STAFF RECOMMENDATION
105 Lindsley Park Drive
February 20, 2013

Application: Demolition-contributing building and New construction-infill
District: Lockeland Springs-East End Neighborhood Conservation Zoning Overlay
Council District: 06
Map and Parcel Number: 08309046400
Applicant: Jim Richie, Owner; Zach Provonchee, Architect
Project Lead: Sean Alexander, sean.alexander@nashville.gov

<p>Description of Project: The applicant is proposing to demolish a contributing house in order to replace it with a new building.</p> <p>Recommendation Summary: Staff recommends disapproval of the application to demolish the contributing building at 105 Lindsley Park Drive as demolition meets section IV.B.1.a. for inappropriate demolition. Staff recommends disapproval of new construction since new construction will require the demolition of the existing building which is inappropriate.</p>	<p>Attachments A: Sanborn Map B: Photographs C: Site Plan D: Elevations</p>
---	--

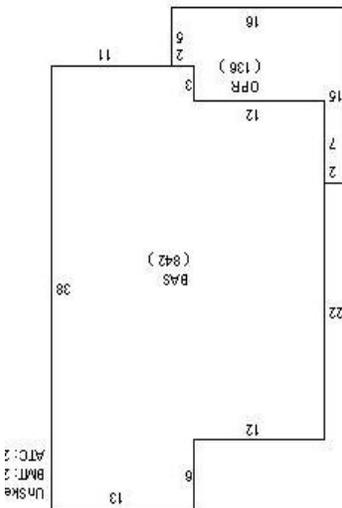
The house has typical Craftsman-style features including three-over-one windows, bracketed eaves, and exposed rafter tails. The foundation is continuous brick with cedar piers, the siding currently is vinyl, and the roof is asphalt shingle. Based on the architectural style, historic context, materials, the development of the street and city directories, the building was constructed circa 1930. It has not undergone any major alterations that have changed its original form and character. The footprint is approximately 842 square feet.

1951 Sanborn Fire Insurance Map

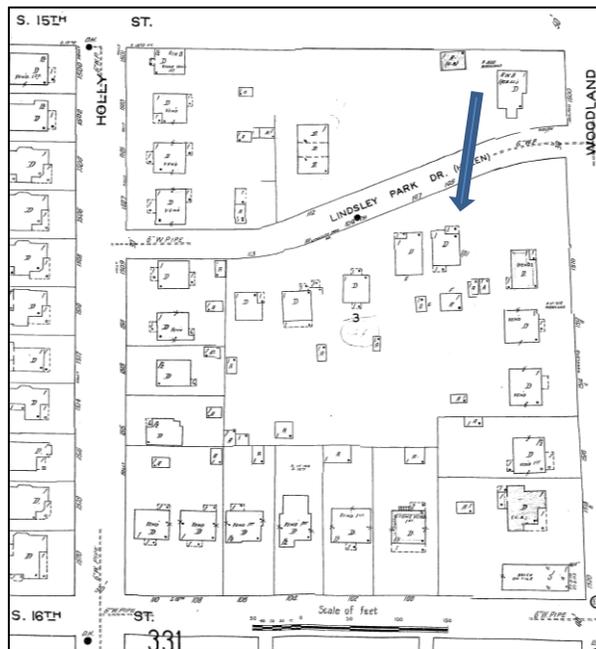
Because the house contributes to the historic character of the district, demolishing it would be detrimental to the public interest. Staff finds that the demolition meets Design Guideline IV.B.1.a. for inappropriate demolition and does not meet section IV.B.2 for appropriate demolition.

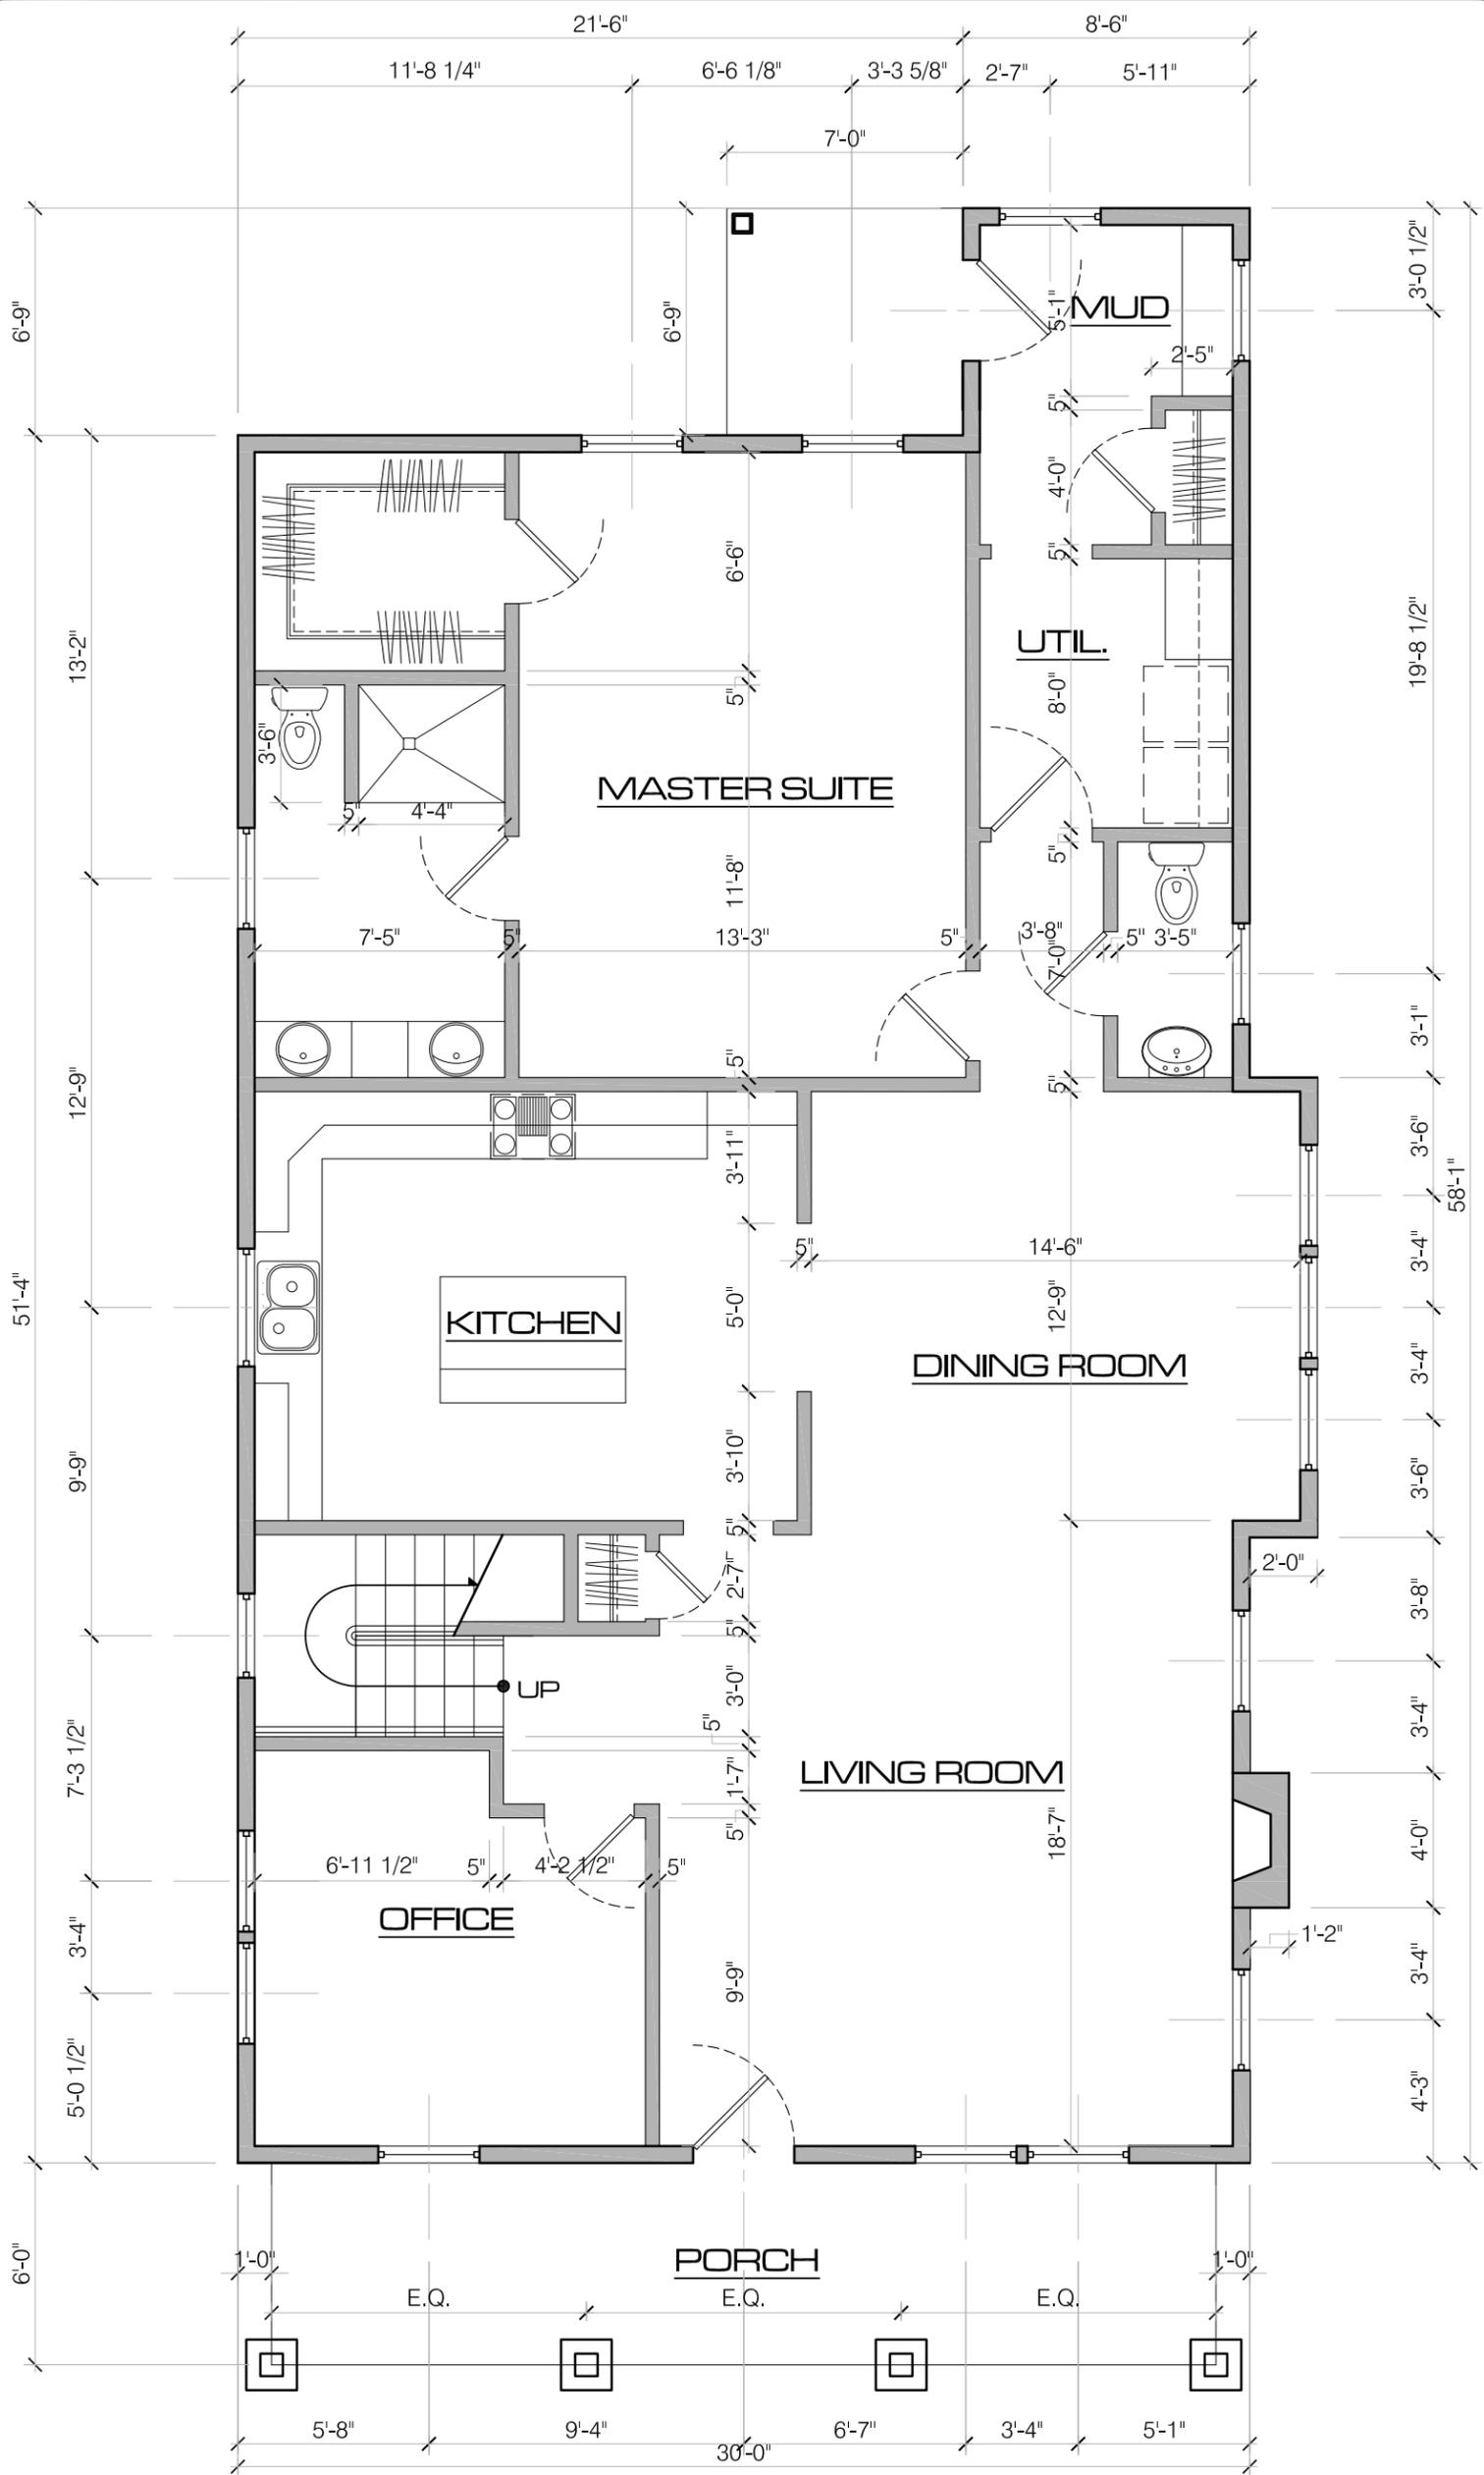
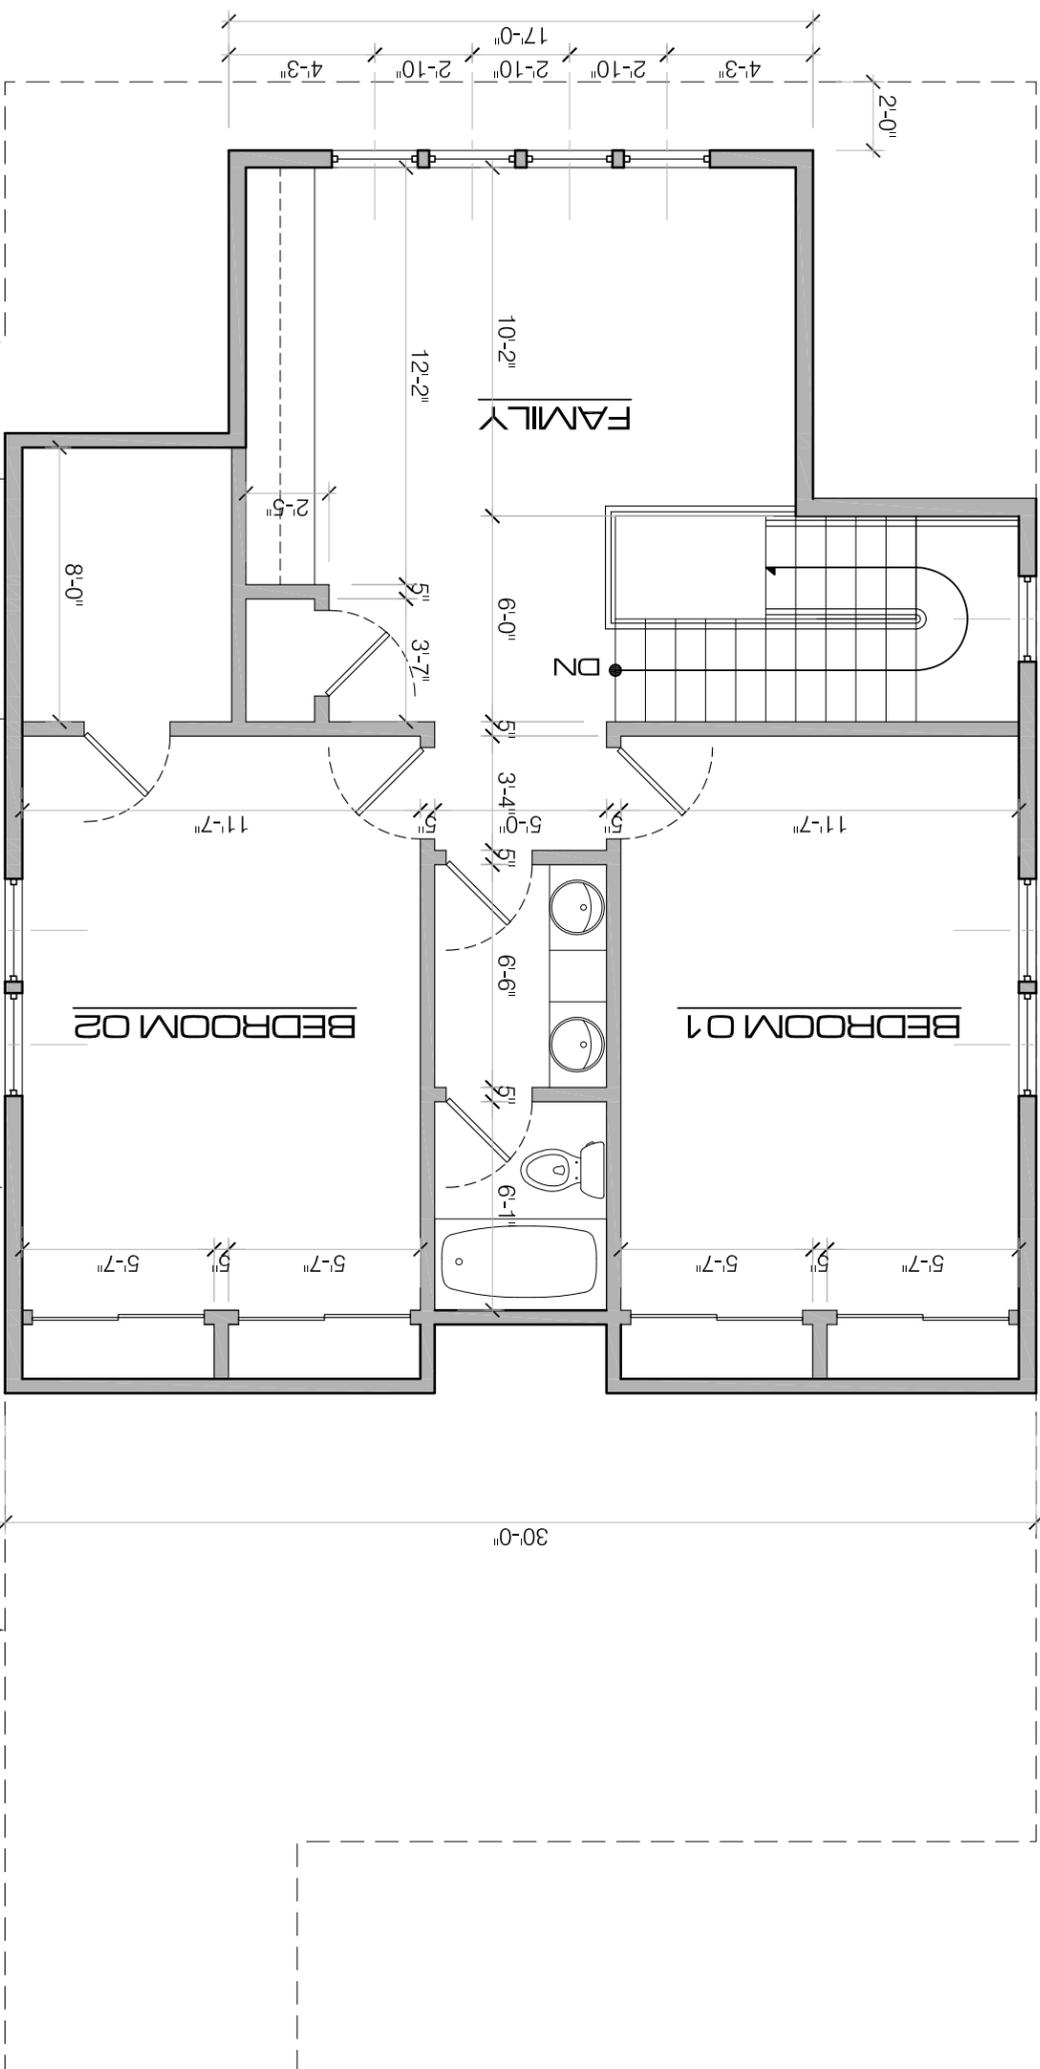
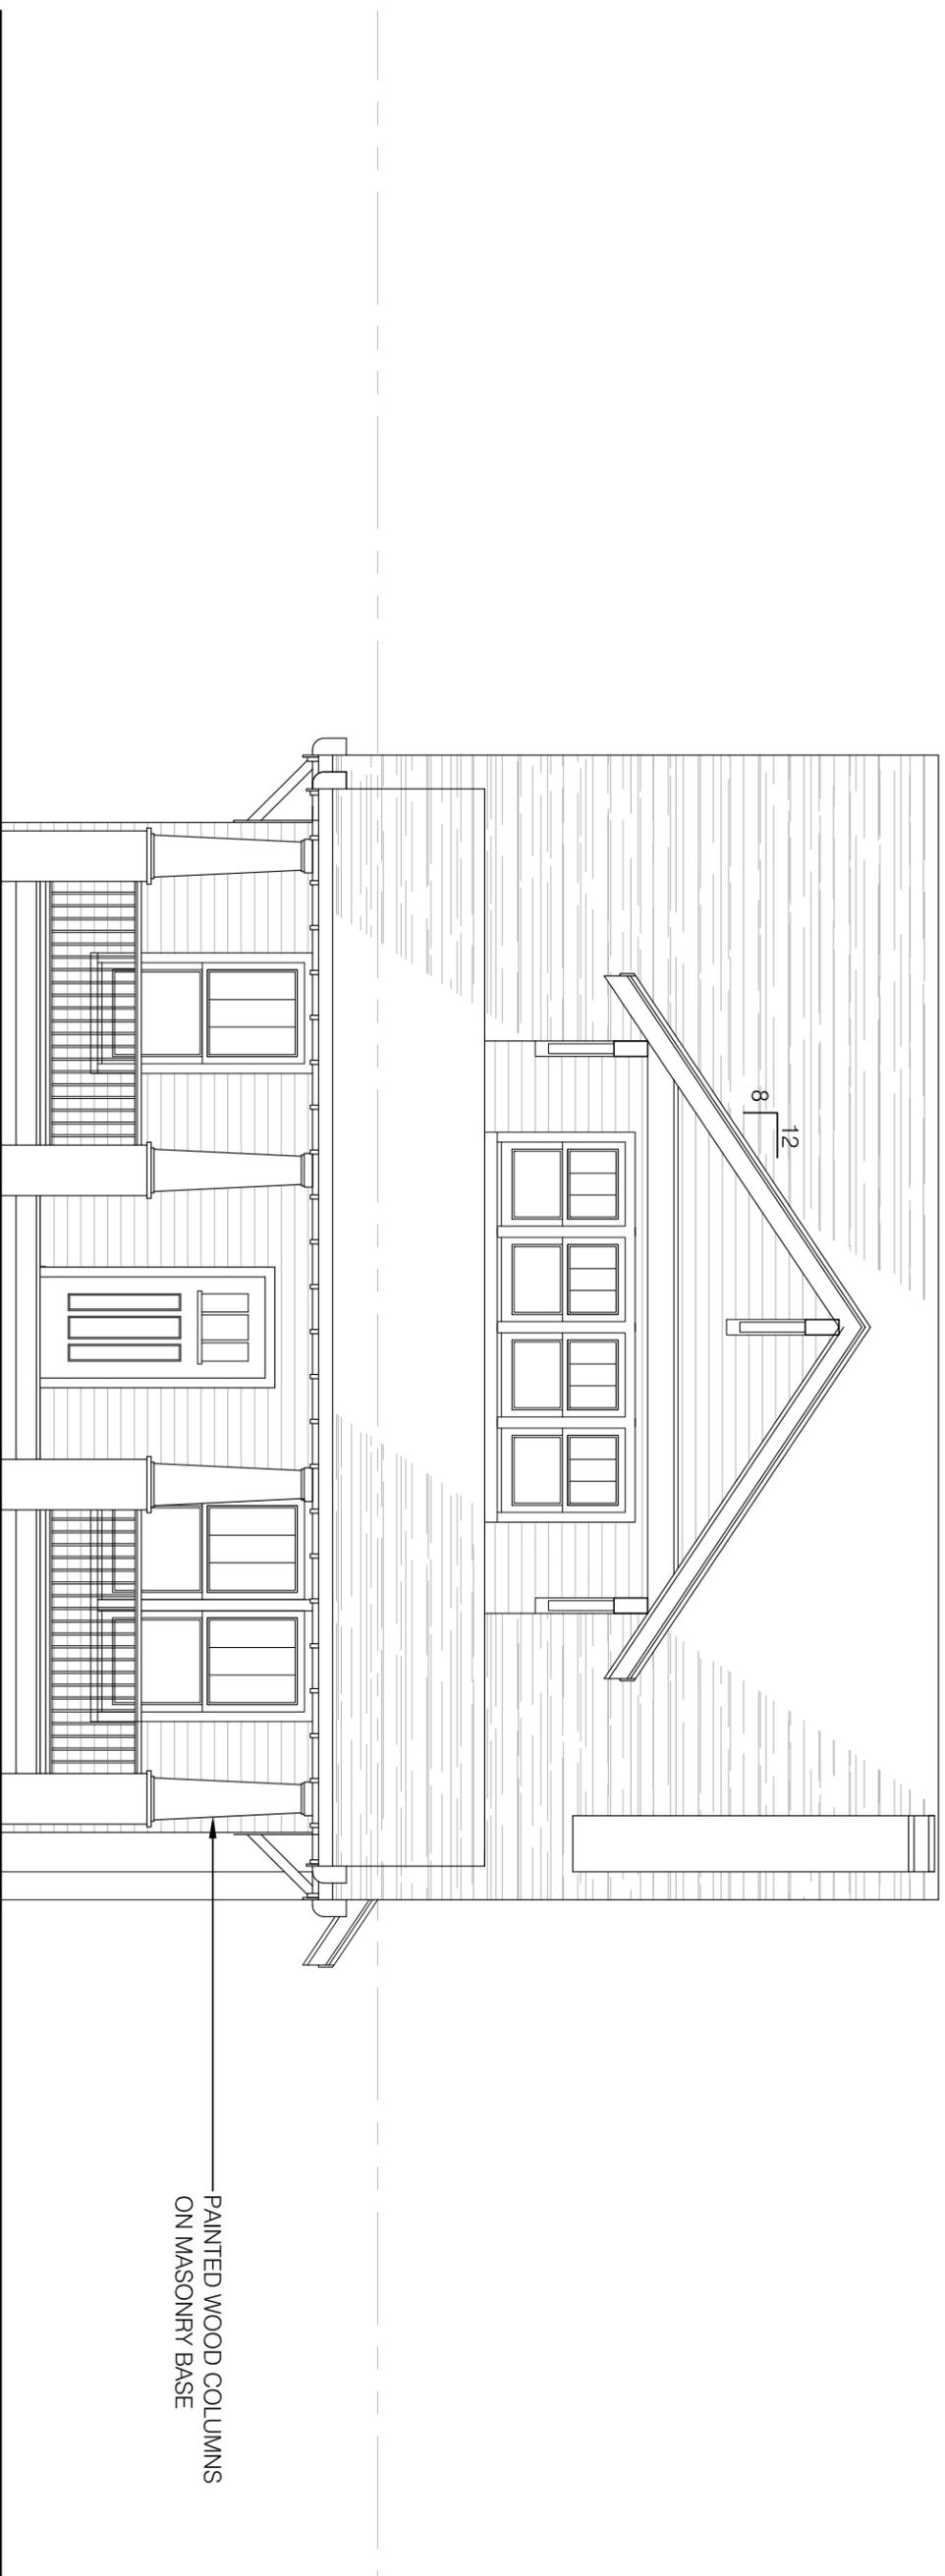
Plans for subsequent new construction were submitted by the applicant. New construction is inappropriate since it will require the demolition of a contributing structure that does not meet the ordinance's requirements for demolition. Staff recommends disapproval of new construction.
